# FCC CLASS II PERMISSIVE CHANGE REQUEST LETTER

Suntech International Ltd.

**RE: FCC Permissive II Change Request for Company: Suntech International Ltd. FCC ID: WA2ST600**

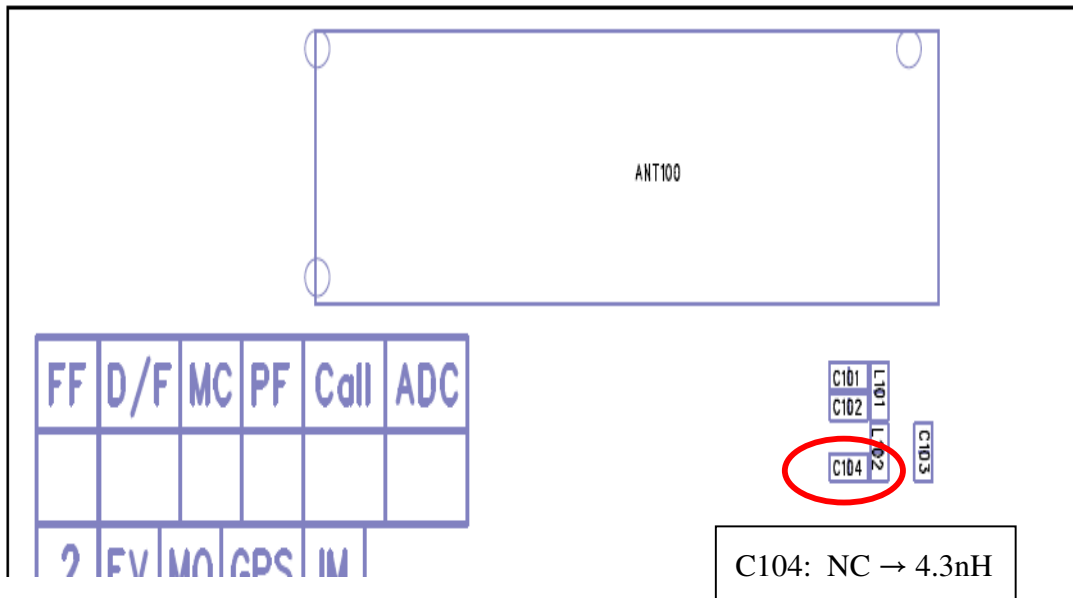
Original Antenna is on the PCB(Main Board).  
But, C2PC Antenna is separate the PCB(Main Board).  
And, antenna matching value was changed(C104: NC -> 4.3nH).
